Item 4.**Development Application: 219-231 Botany Road, Waterloo - D/2020/1419****File No.:** D/2020/1419**Summary****Date of Submission:** 20 January 2021, amendments submitted up to and including 27 May 2022**Applicant/Developer/Owner:** HYG**Architect:** Cottee Parker Architects Pty Ltd**Planning Consultant:** Mecone**DAP and DAPRS:** 22 April and 4 May 2021**Cost of Works:** \$40,882,000**Zoning:** The site is located in the Zone B4 Mixed Use. The proposed development comprises retail and residential uses which are permitted with consent in the zone.**Proposal Summary:** The subject Development Application (DA) D/2020/1419 seeks consent for the demolition of all existing structures, tree removal, excavation and remediation and construction of a mixed-use development comprising 132 apartments in three buildings.

Figure 41: The proposed development has a height of up to 25.97m and exceeds the 22m height control by up to 3.97m

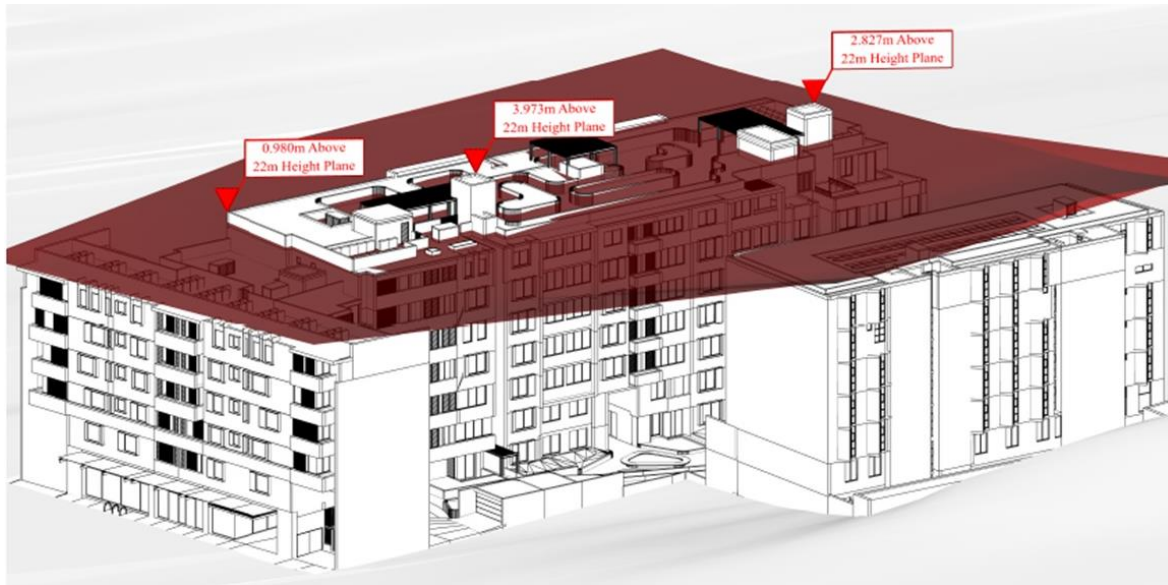
123. The site is subject to a maximum building height control of 22m. As shown in Figure 41 below, the proposed development has a maximum height of up to 25.97m and exceeds the LEP's 22m height control by up to 3.97m or 18 per cent.
124. As shown in Figure 41 below, the building elements that breach the LEP's 22m height control are atop Buildings A and B and include:
- (a) lift and stair overruns;
 - (b) shade structures, planters; and
 - (c) the north-western corner of the substantive roof structure that forms part of the rooftop common open space.

Figure 44: Comparison of the 3D CAD models of both the concept envelopes (as modified by D/2015/1358/C) and the detailed design DA scheme, with significant building elements that protrude outside of the envelope circled in white dashed line

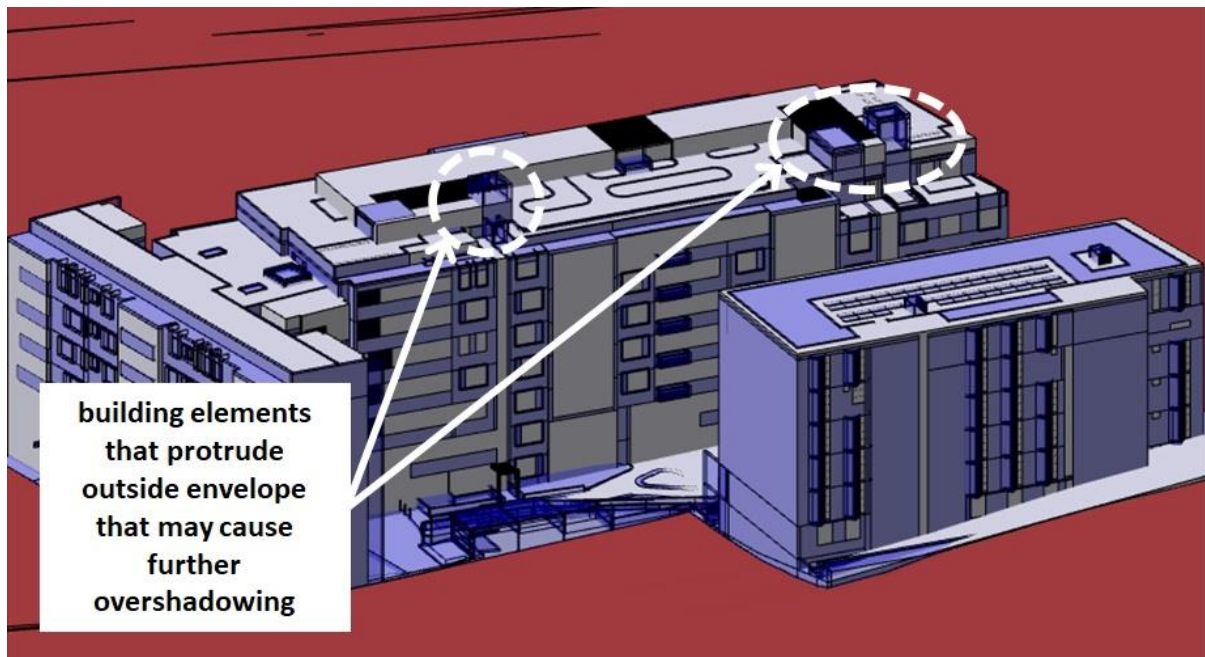
152. Figure 44 above is an image of a comparison of the 3D CAD models of both the concept envelopes (as proposed to be modified by D/2015/1358/C) and the detailed design DA scheme.

153. As Figure 44 above illustrates, all substantive building elements, with the exception of stair and lift overruns [which are permitted by condition (6) of concept consent D/2015/1358/C to be unconstrained by the envelope], are contained within the concept envelopes (as proposed to be modified by D/2015/1358/C).

155. The overshadowing impacts of those significant building elements circled in Figure 44 above and which protrude outside of the concept envelopes as proposed to be modified by D/2015/1358/C are discussed as follows.

Figure 56: Approximation of view impacts arising from the originally approved envelopes

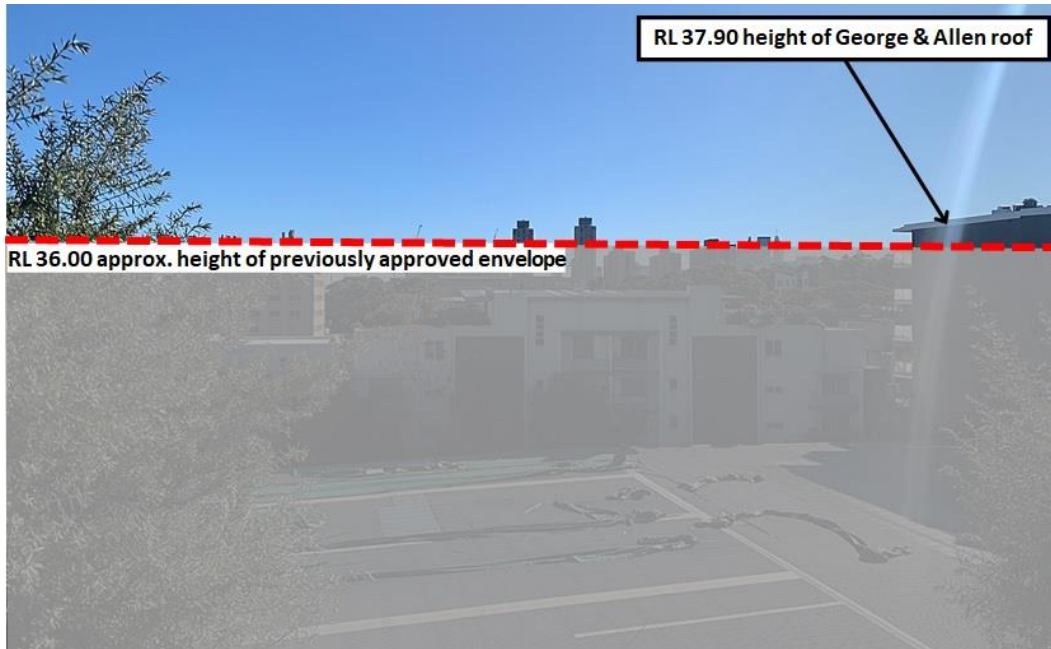
170. As shown in Figure 56 below, the concept envelopes as originally approved would have blocked most of the views of the City skyline. The remaining views of the City skyline that are likely to be blocked by the modifications proposed under application D/2015/1358/C (being assessed at the same time as the subject DA) could only be considered very partial views.

Figure 57: Approximation of view impacts arising from the proposed modified envelopes

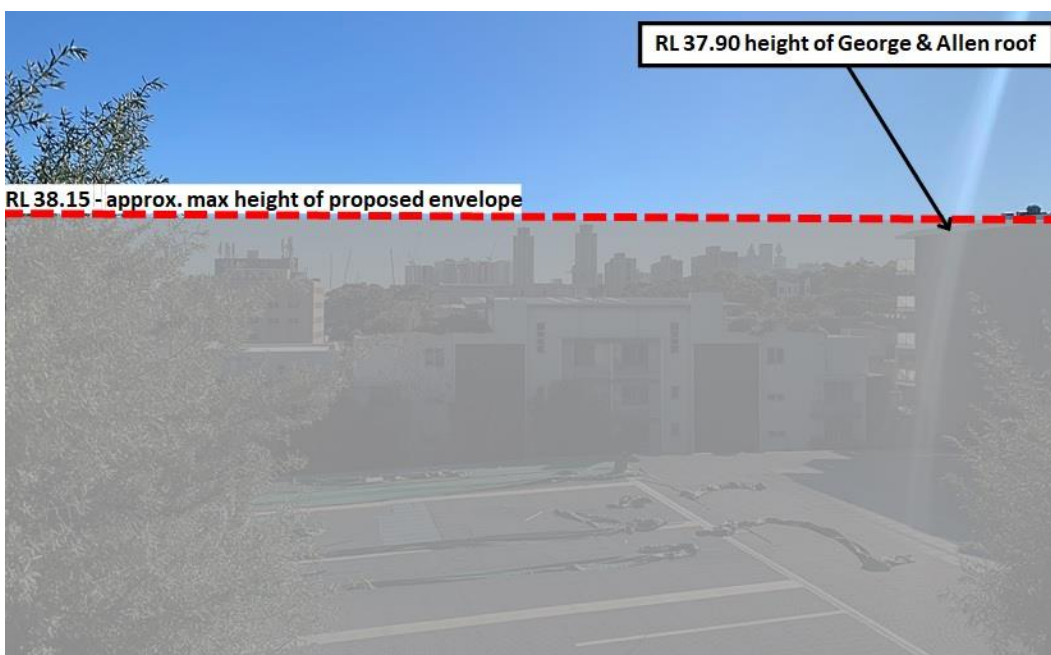
171. As shown in Figure 57 below, the modifications proposed under application D/2015/1358/C (being assessed at the same time as the subject DA) to increase the height of the Building A and B envelope will block out the last glimpses of those tallest towers of the Waterloo Estate.

Figure 58: Ground level drawings to be amended to remove kerbs, apply high-quality finishes and remove bollards

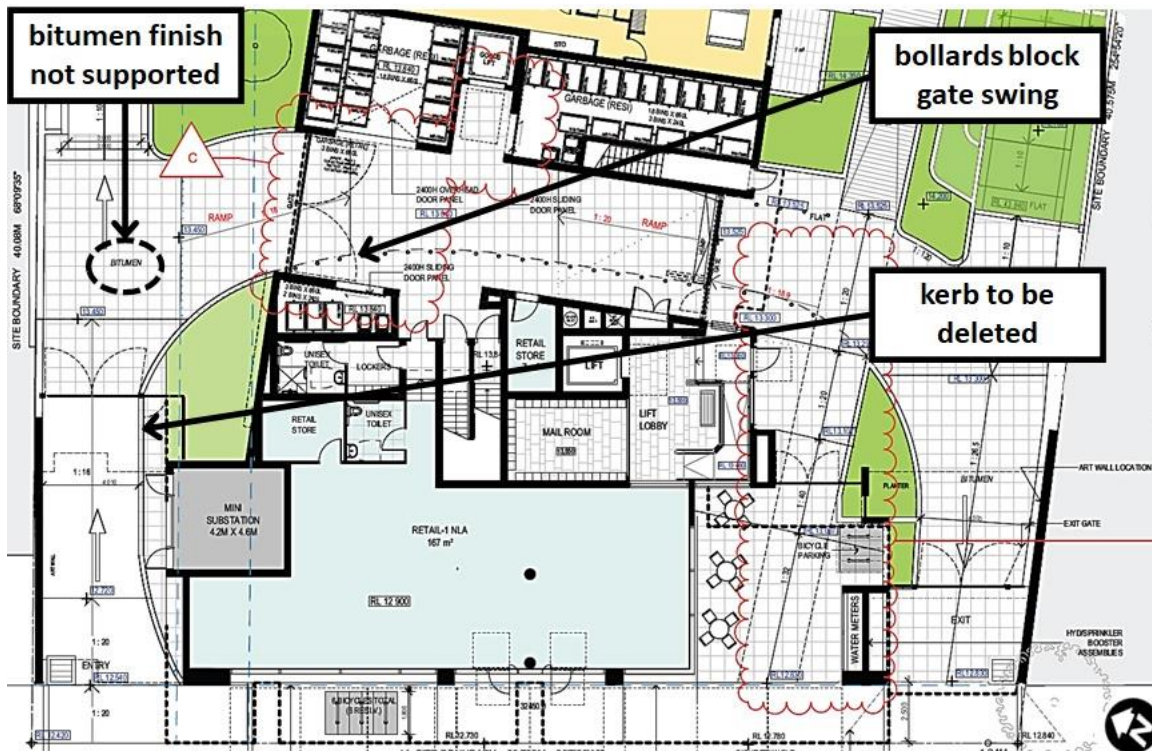
176. However, as shown in Figure 58 below, there appear to be some elements of earlier iterations of the design that have not been updated on the drawings, including:

- (c) bollards located at the northern end of the driveway block the opening operations of the loading dock gate;
 - (d) the awning, retail facade, integrated services and metalwork are either insufficiently detailed in the DA drawings. Especially the suite of standard entrance gates facing Botany Road. The quality of these elements and their architectural integration is key to presenting well to the public domain and to achieving design excellence.

177. Conditions are recommended for design modifications and additional information to be submitted to address these concerns.

Figure 59: Condition is recommended for the design of centrally located balconies and planters to be modified so that they project over the public domain by no more than 450mm

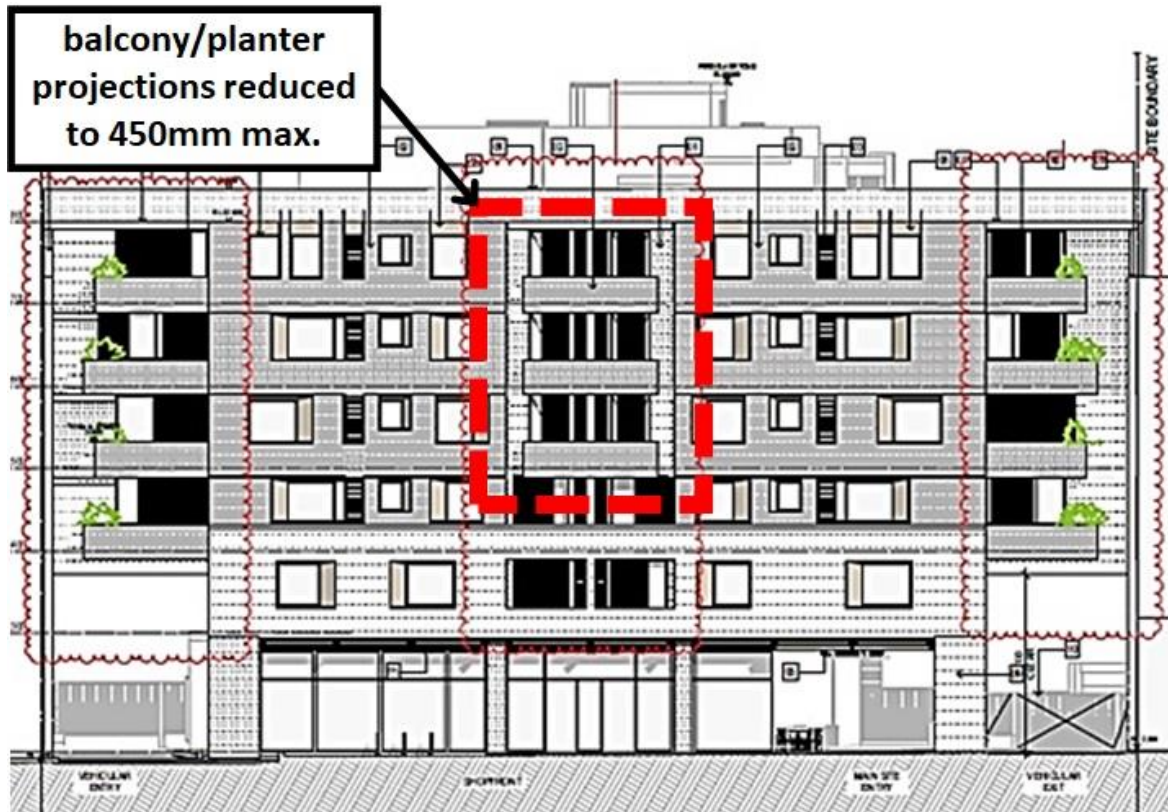
181. In accordance with DCP requirements most of the facade elements described above cantilever into or overhang the public domain by no more than 450mm. However, as shown in Figure 59 below, centrally located balconies in the Botany Road facade project 500mm into the public domain.

182. A condition is recommended for the design of these balconies and planters to be modified so that they project into the public domain by no more than 450mm.

Figure 60: Conditions are recommended for design modifications to the balcony of apartment A1.203 and the nearby corridor to improve privacy and to improve maintenance access to the corridor planter

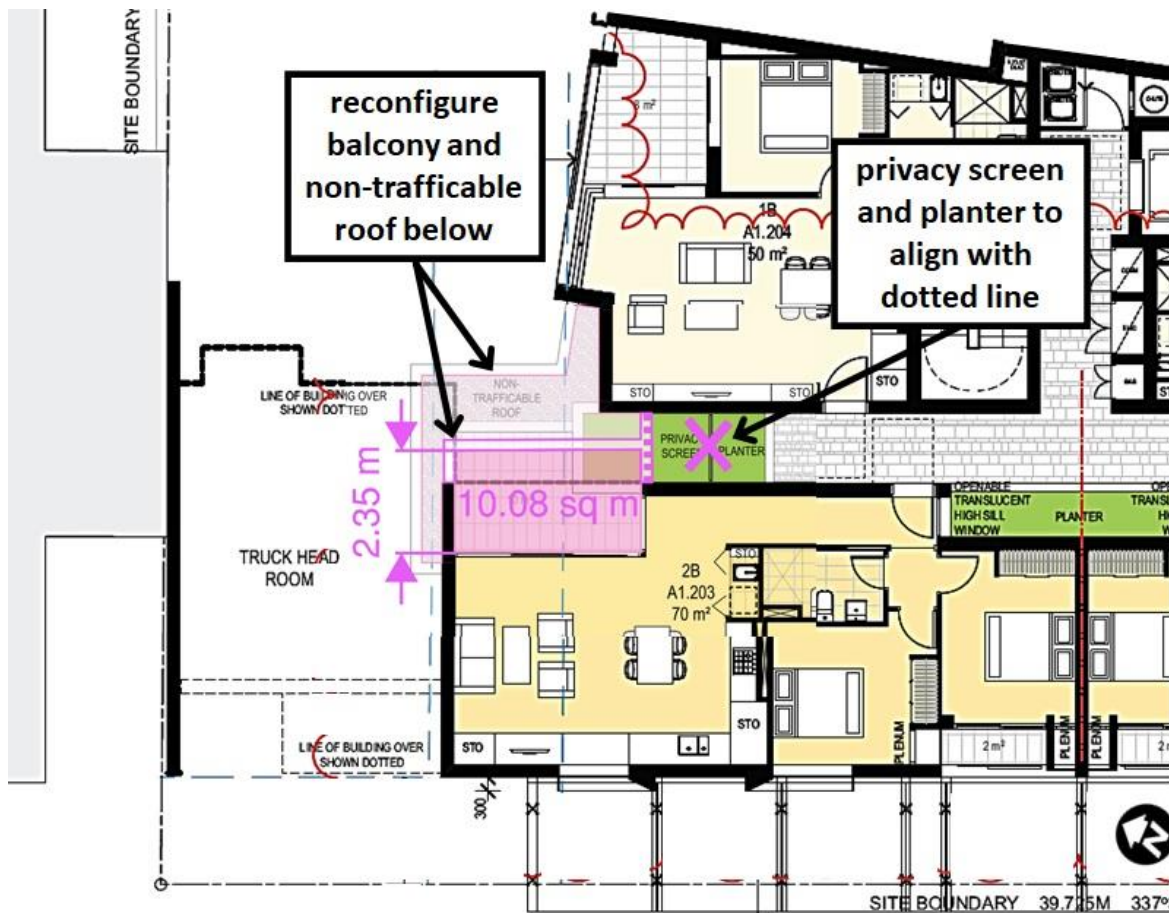
184. A condition is recommended for the following design modifications to the balcony of apartment A1.203 and the nearby corridor to improve privacy and to improve maintenance access to the corridor planter, as illustrated in Figure 60 below:

- (d) amend the design of the inaccessible roof with gravel finish that adjoins the balcony to accommodate the design modifications specified above; and

- (e) provide operable sliding privacy screens on the balcony upstand wall for privacy.

Figure 61: Conditions are recommended for design modifications to increase the size of balconies of apartments A1.302/A1.303/A1.402/A1.403/A1.502/A1.503/A1.602/A1.603

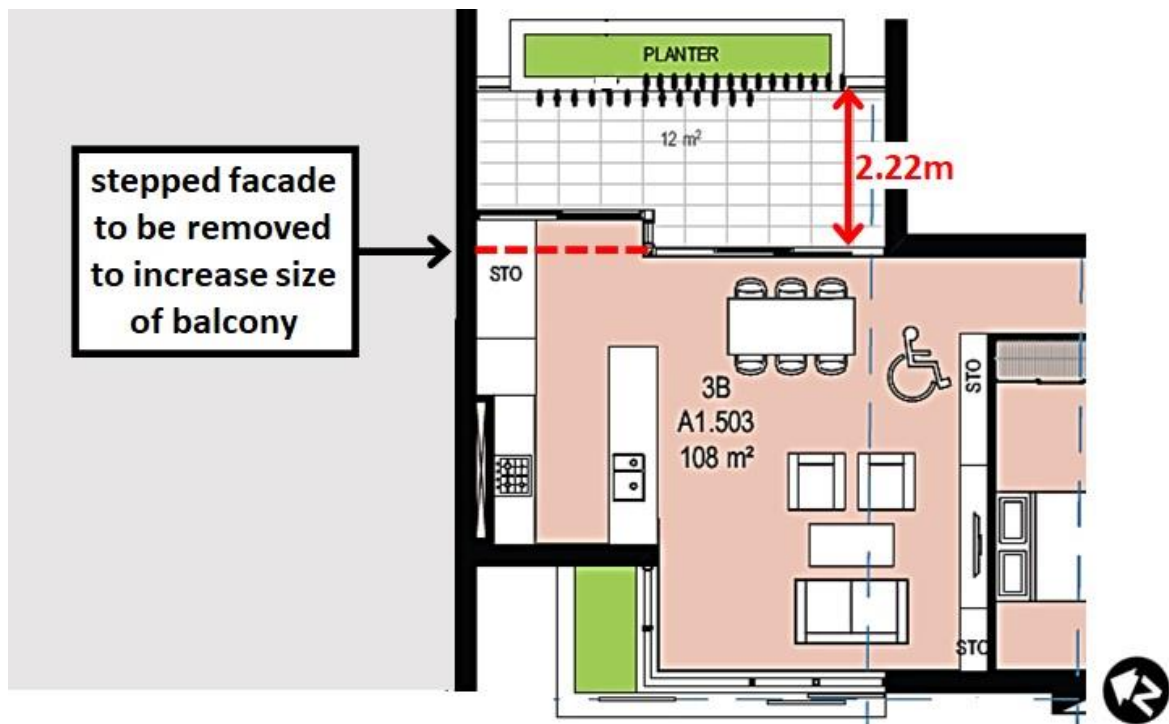
187. The balconies to 3-bedroom apartments in Building A1 (fronting Botany Road) do not achieve the 2.4m minimum dimension requirement.

188. A condition is recommended for these balconies to be increased in area to compensate for this non-compliance and to improve the useability of the space provided. This is to be achieved by removing the step in the east-facing balcony facade as shown in Figure 61 below.

Figure 62: Conditions are recommended for design modifications to improve privacy to clerestory windows that are located near common open space areas

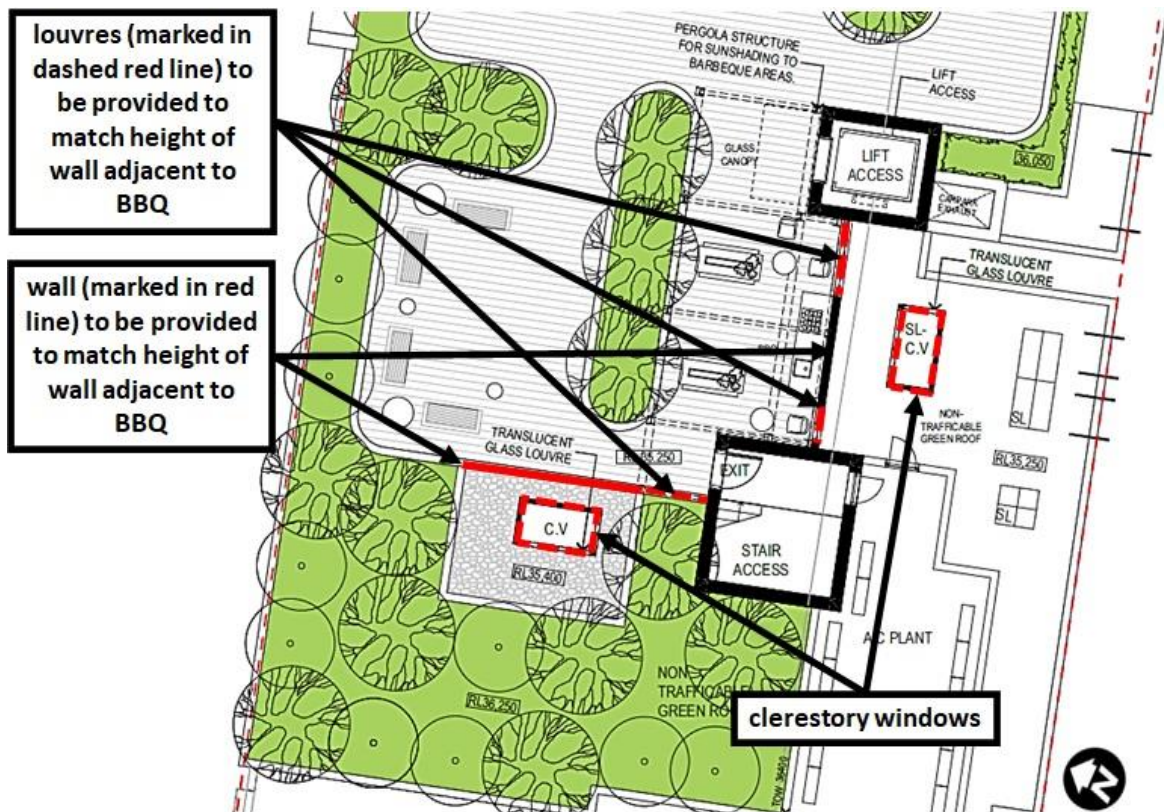
189. As is discussed elsewhere in this report, 60 per cent of apartments in the proposed development are naturally cross ventilated in accordance with the design criteria to ADG objective 4B-3.
190. Some level 7 apartments rely on clerestory windows that are adjacent to common open space areas to achieve natural cross ventilation.
191. Conditions are recommended to improve the privacy to clerestory windows to apartments A2.701 and A2.704, as illustrated in Figure 62 below.

Figure 63: Deep soil areas to be annotated on the approved drawings

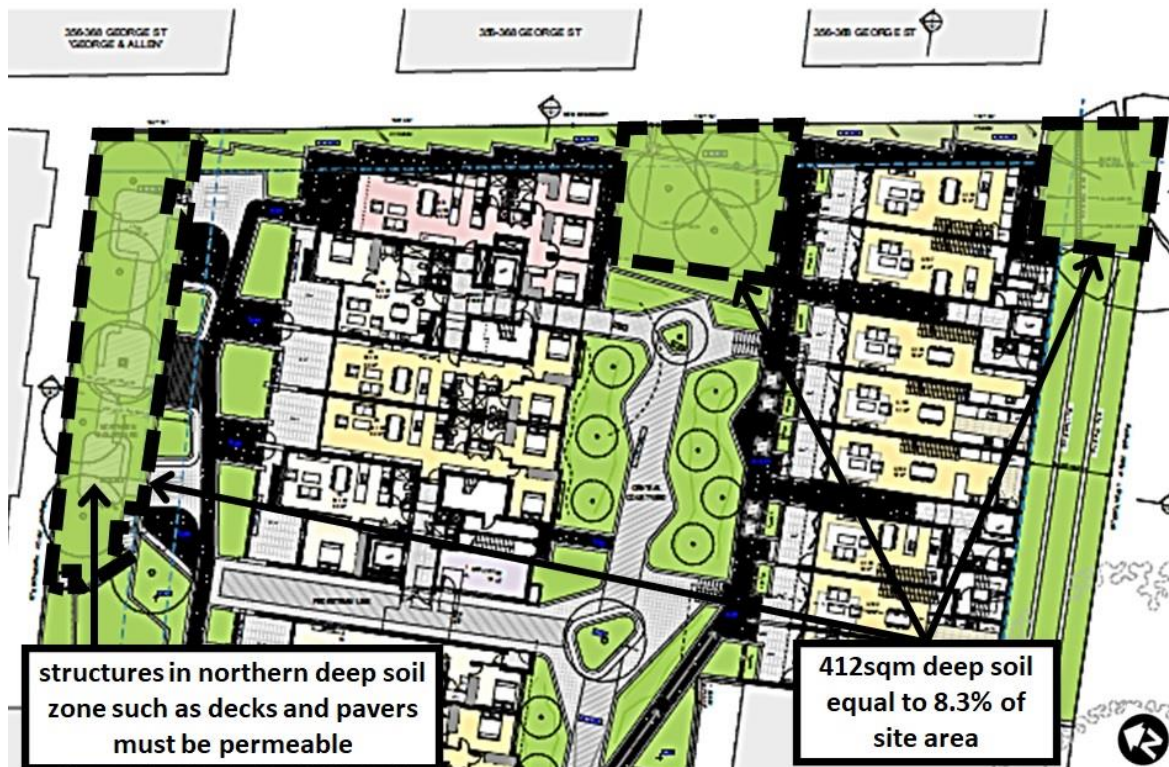
195. It is noted that the steep terraced area along the southern site boundary will require engineered retaining walls with substantial footings and cannot be considered deep soil. It has been excluded from the calculation of deep soil areas for this reason.

196. A condition is recommended for deep soil areas shown in Figure 63 below to be clearly marked on the architectural drawings. The recommended condition also specifies that any structures such as decking or paving in these areas are to allow for filtration of rainwater into the ground.

Figure 64: Excerpt from submitted Tree Identification Plan showing locations of trees numbered T1, T2, T3, T4, T6 and T7

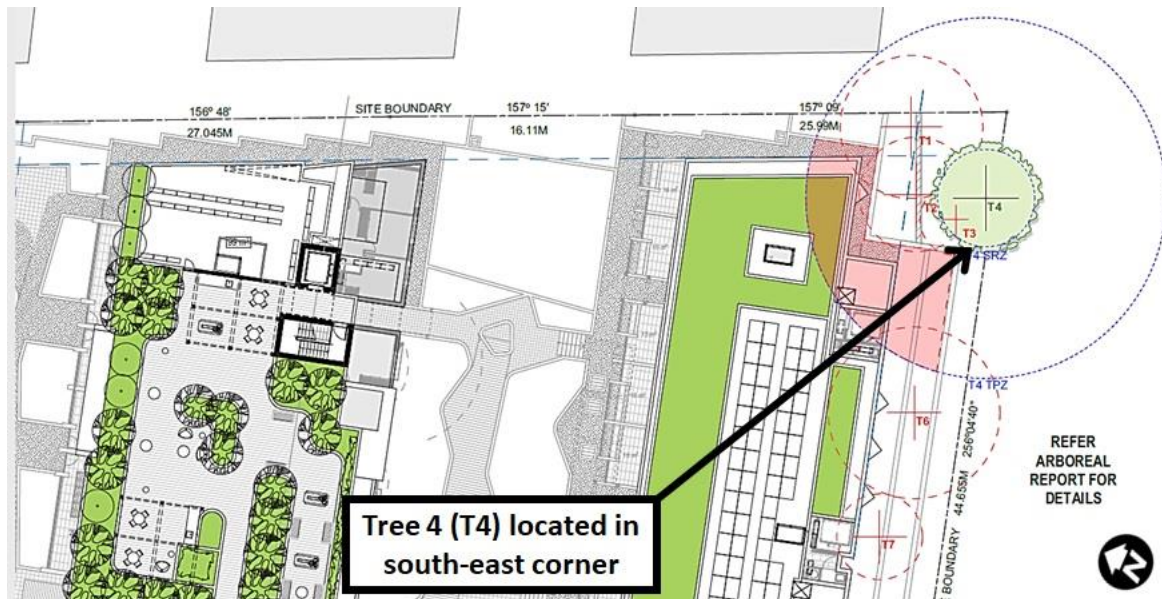
197. Trees numbered T1, T2, T3, T5, T6 and T7 are proposed for removal. Council's Tree Management Officers do not object to the removal and replacement of these trees.
198. The largest specimens are trees numbered T1 and T2. These trees are located in the south-eastern corner of the site in close proximity to tree T4 and which is shown in Figure 64 below. Trees T1 and T2 are multi-stemmed Port Jackson Figs. They appear to be self-seeded and are not sustainable in their current locations.

199. As shown in Figure 64 above, tree T4 is located in the south-east corner of the site.
